On-Property Corrective Measures Implementation Construction Completion Report

Subject:
On-Property CMI Construction Documentation Report
Koppers Inc. Superior, Wisconsin Facility
WDNR BRRTs No: 0216000484
WDNR Facility ID: 816009810

**On-Property Corrective Measures
Implementation Construction
Documentation Report**

Koppers Inc. Facility
Superior, Wisconsin

FIELD ORDER NO. 001

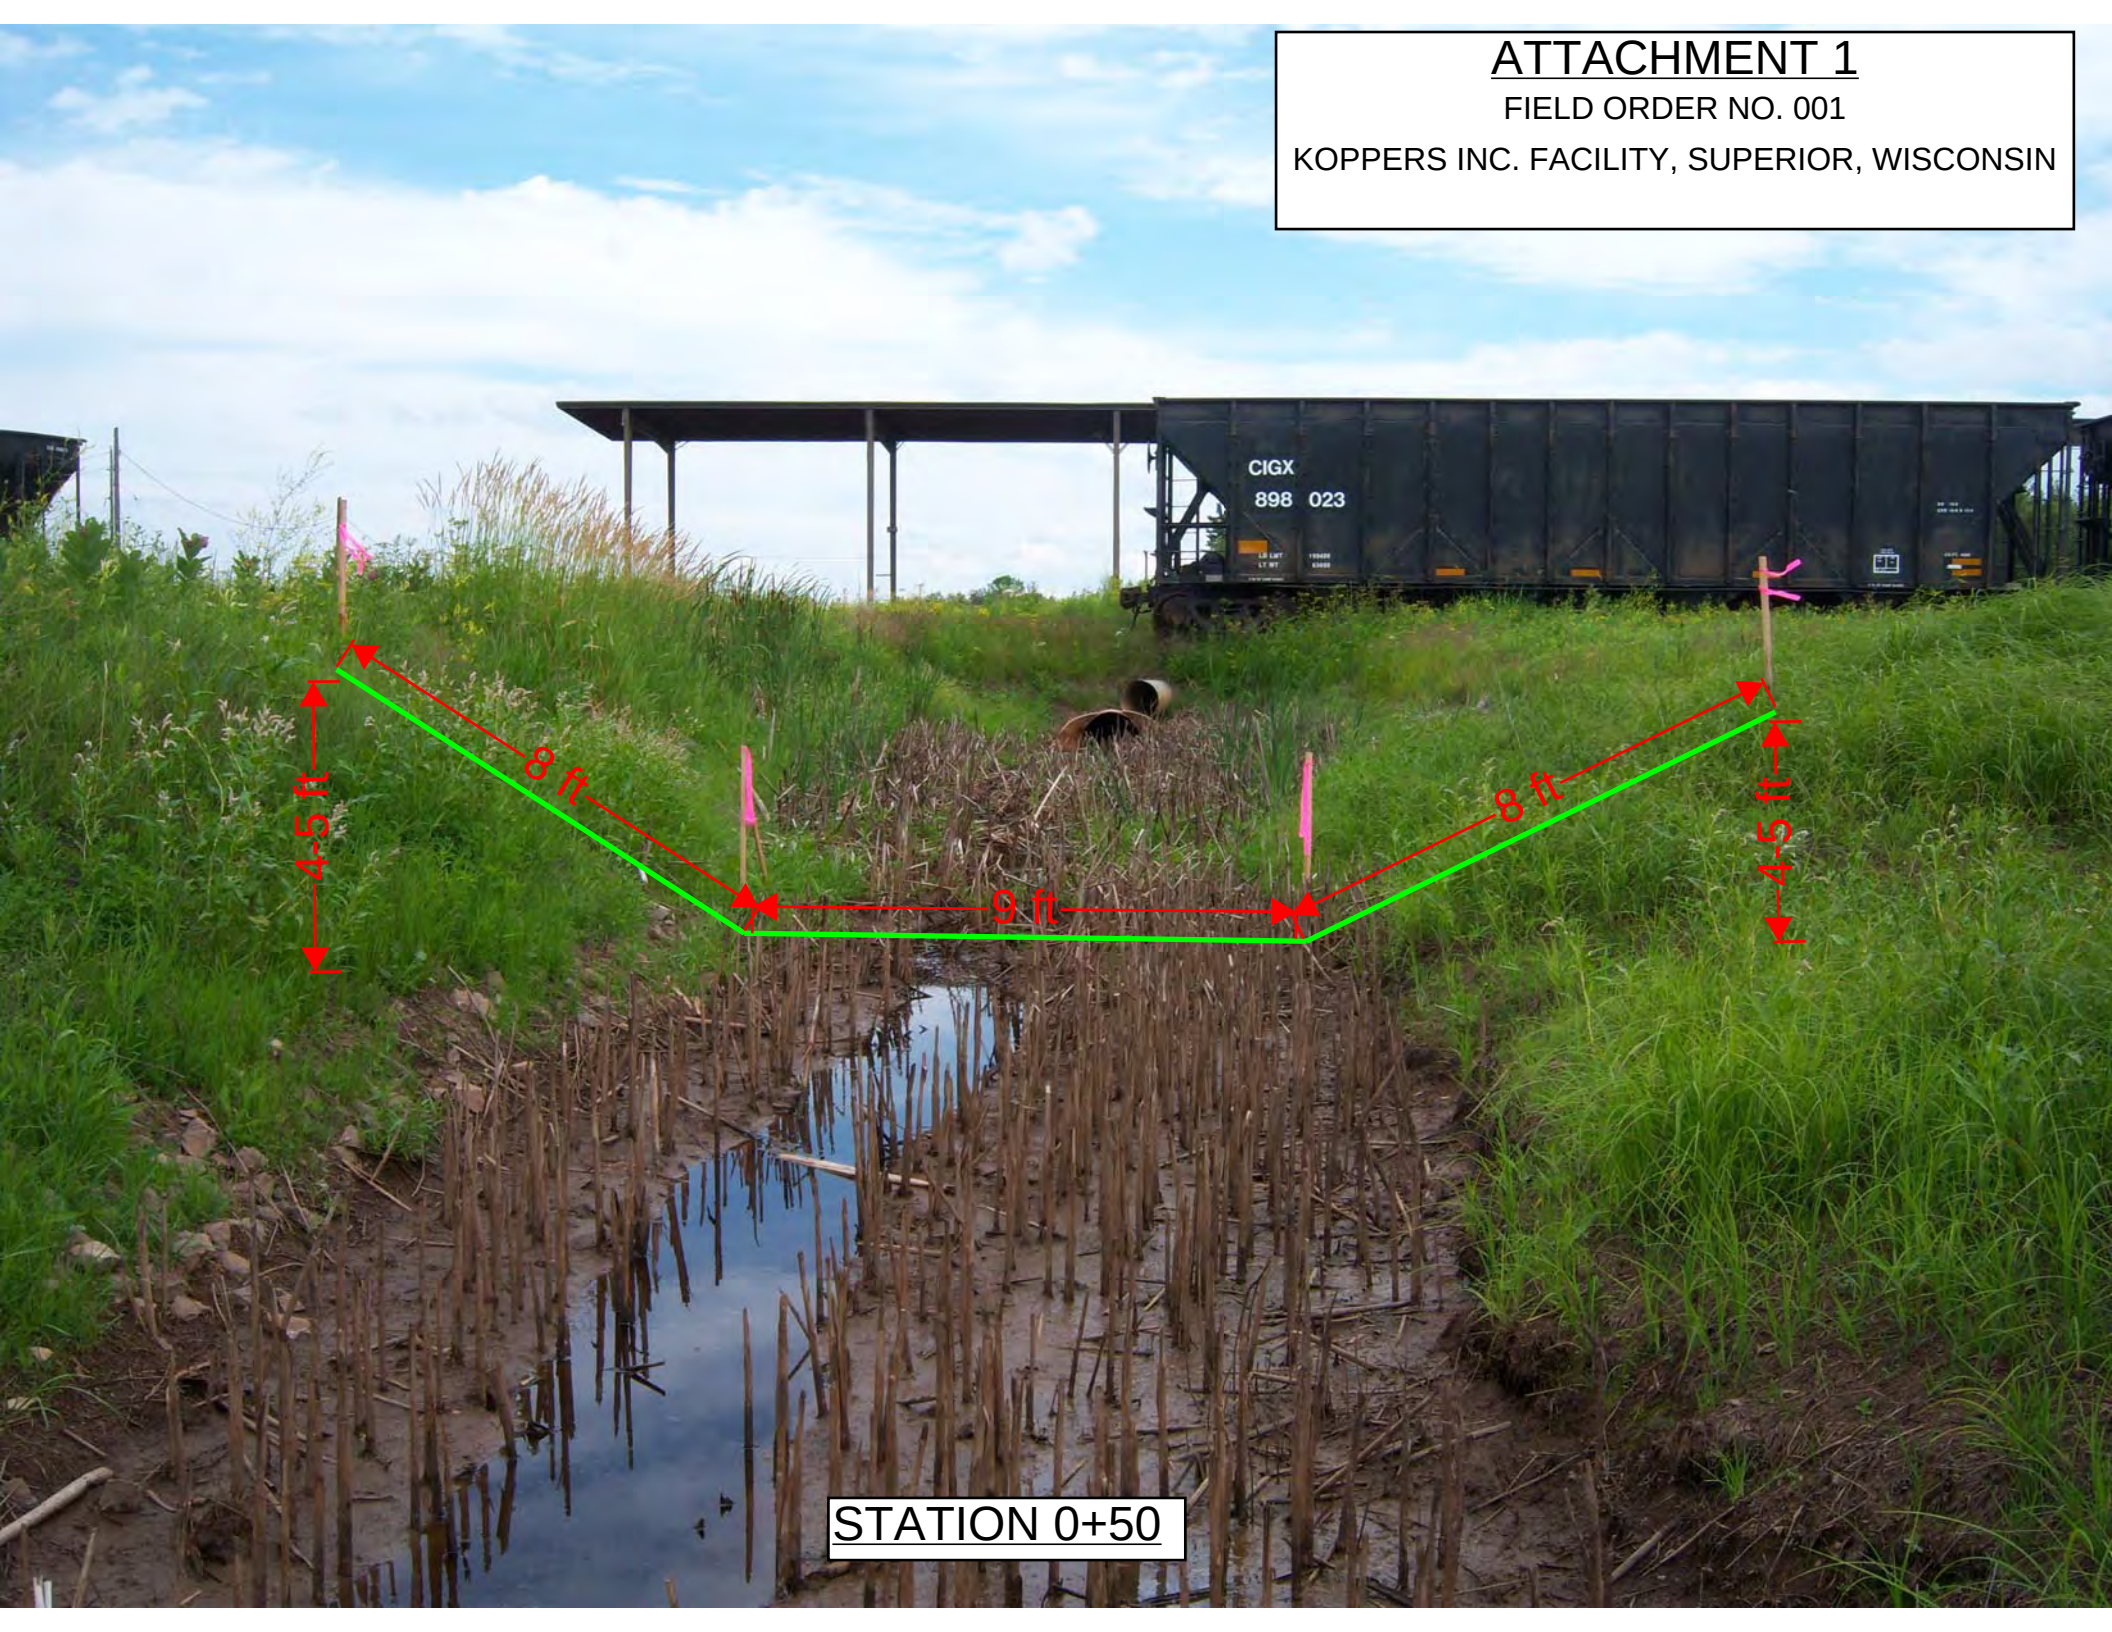
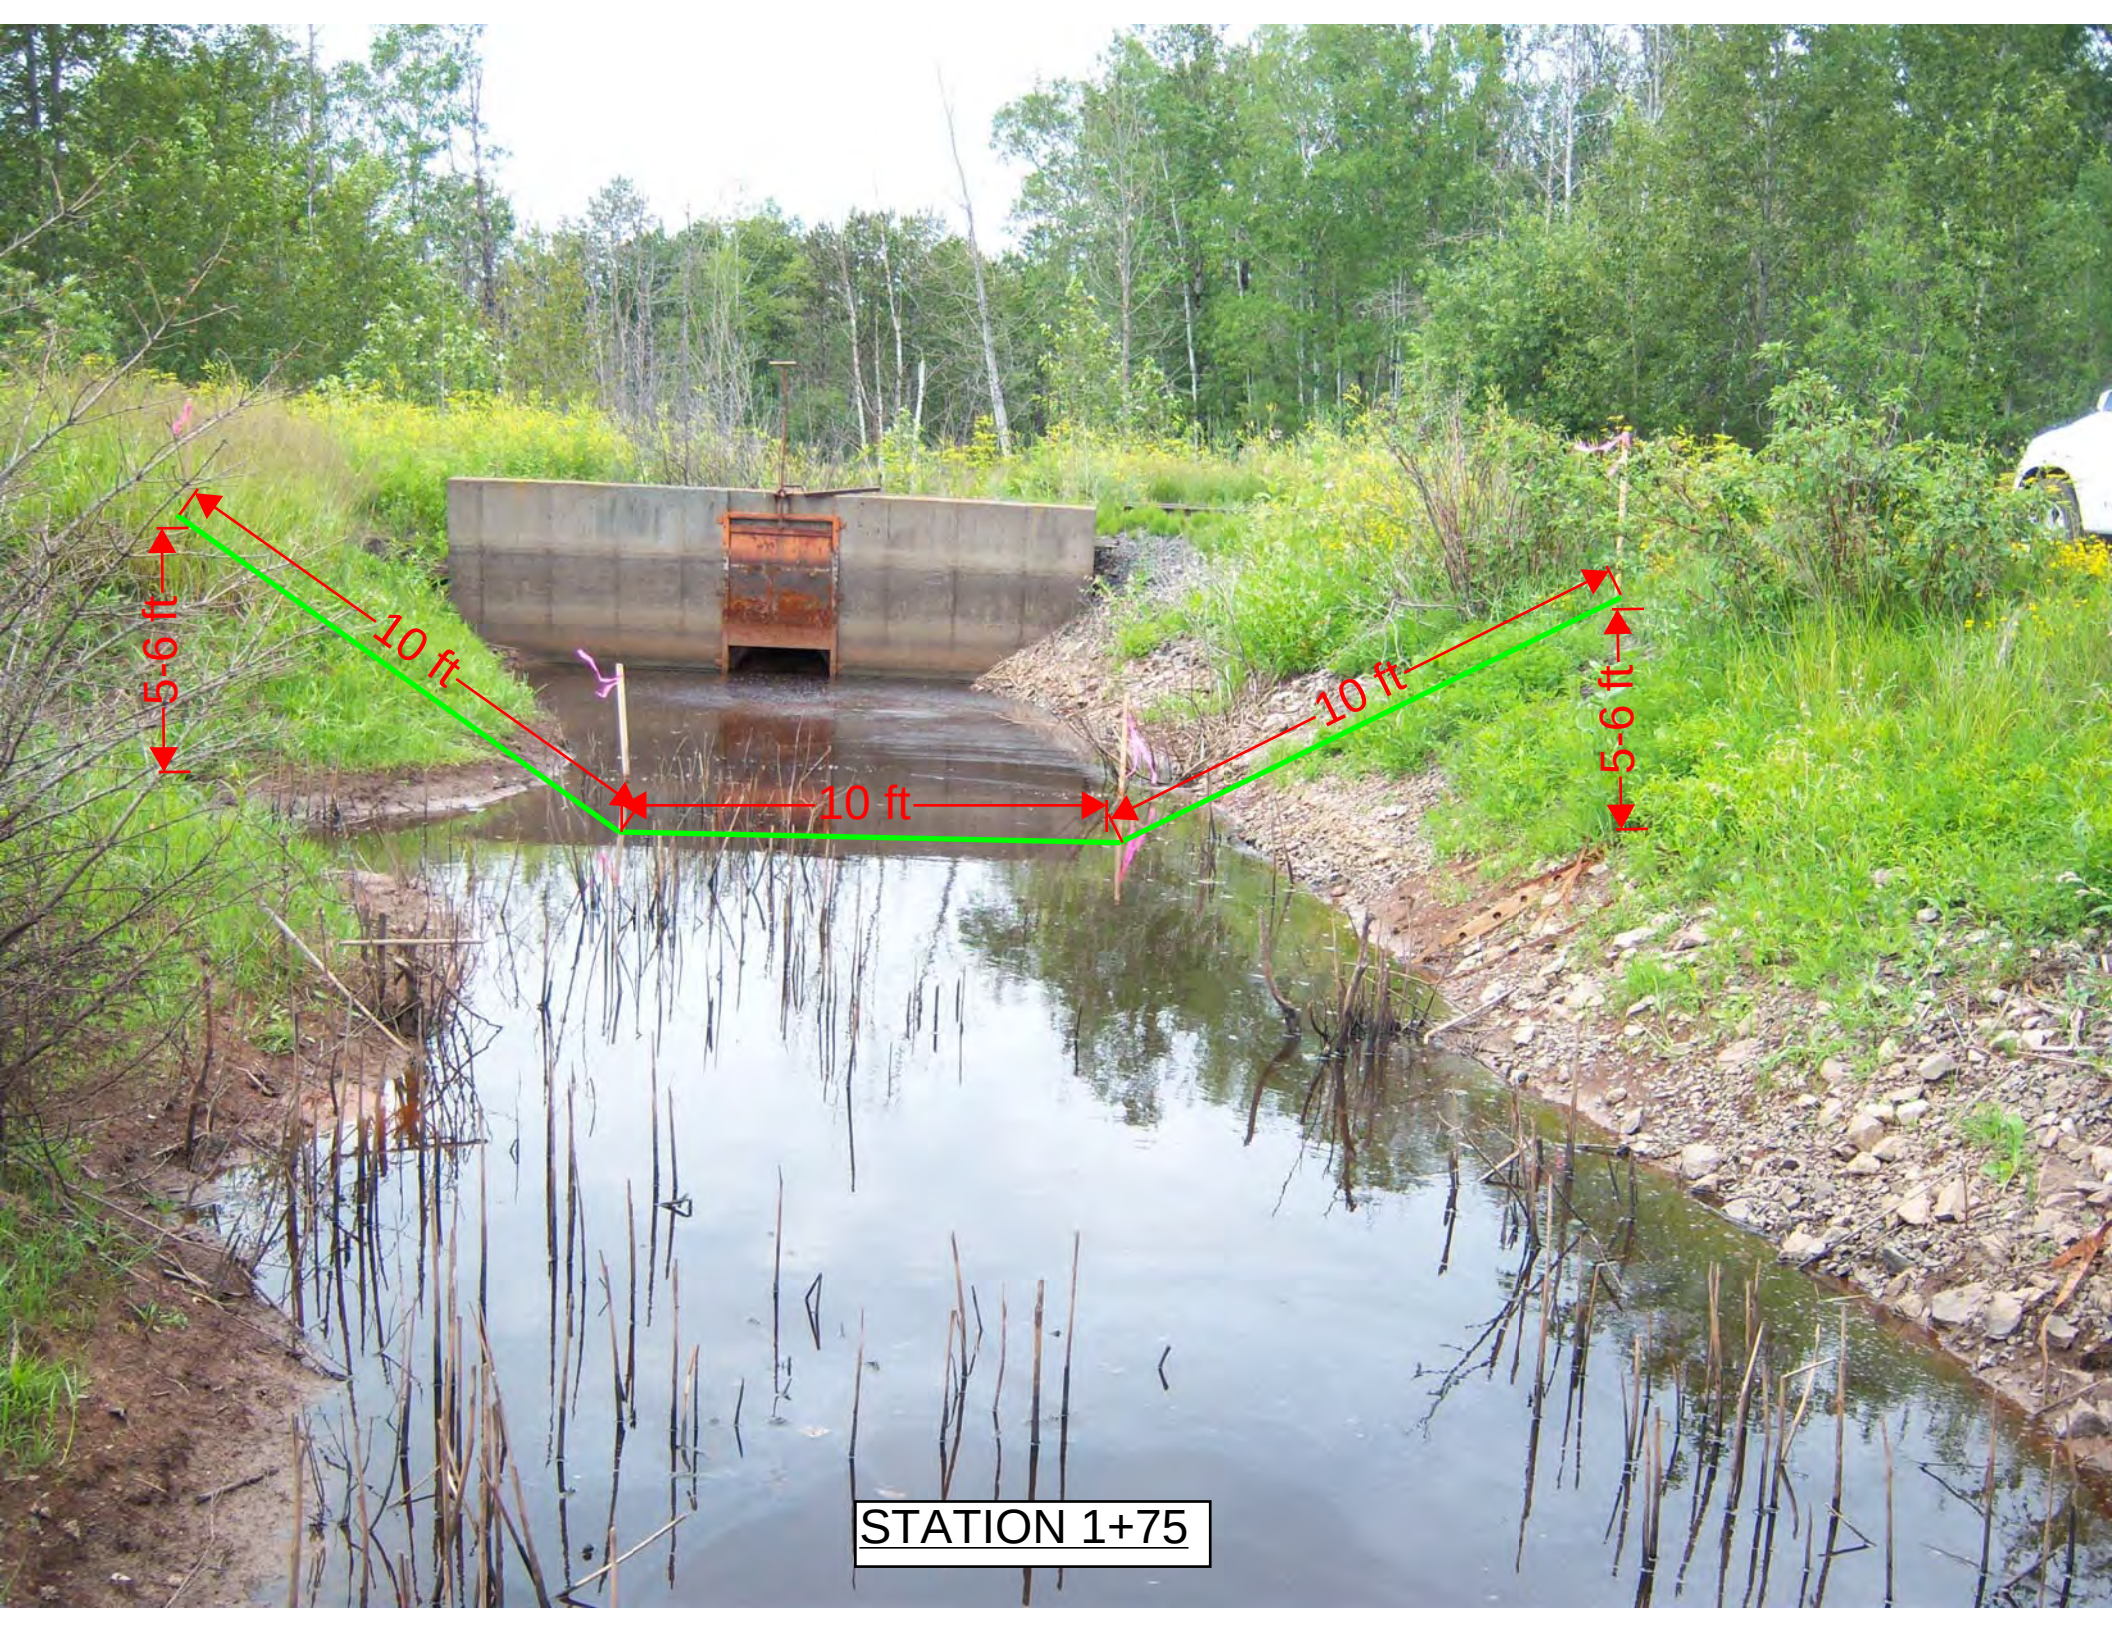
As discussed during the June 11, 2010 meeting at Severson's office in Delmont, Pennsylvania, due to high water in the Outfall 001 drainage ditch during the pre-design survey, the surveyor was unable to record the existing channel geometry. The typical on-property channel cross-sections depicted on Contract Drawing C301, which represent the minimum restored channel dimensions required to maintain proper Facility drainage, were used by Severson to determine the necessary quantities of the Outfall 001 drainage ditch restoration materials for their "Gray Book" Project Cost Estimate (Gray Book). Because the channel should not be filled with additional materials to achieve the minimum dimensions shown on Contract Drawing C301, the quantities of Outfall 001 drainage ditch restoration materials included in the Gray Book are potentially less than the actual required restoration material quantities. As an alternative to hiring a surveyor to conduct an additional survey of the Outfall 001 drainage ditch during lower-water conditions so that the restoration material quantities could be verified, Beazer decided to increase the Outfall 001 drainage ditch restoration material quantities by 30%.

During a July 13, 2010 site visit by ARCADIS, it was noted that the Outfall 001 drainage ditch water levels were low and the actual existing channel geometry at three locations was recorded. Photographs of these three transects and the existing channel dimensions are included as Attachment 1. As shown in Attachment 1, the existing channel dimensions, and therefore the restored channel dimensions, are increased from than the typical on-property channel cross-sections depicted on Contract Drawing C301.

ARCADIS calculated the quantities of all Outfall 001 drainage ditch restoration materials. The following table compares the quantities included on Contract Drawing C100 and the "Estimate Worksheet – Outfall Drainage Ditch Restoration" of the Gray Book with the estimated required quantities based on the existing channel geometry measured on July 13, 2010:

Material	C100 Quantity	"Gray Book" Quantity	Revised Quantity
Pea Gravel	--	390 ton	306 cy ^{1,2}
Reactive Core Mat	--	1,850 square yards (sy)	2,377 sy ³
General Fill	--	240 cy	344 cy
Non-Woven Geotextile	--	20,800 square feet (sf)	28,405 sf ³
R3 Riprap	900 cy	1,170 ton	915 cy ²
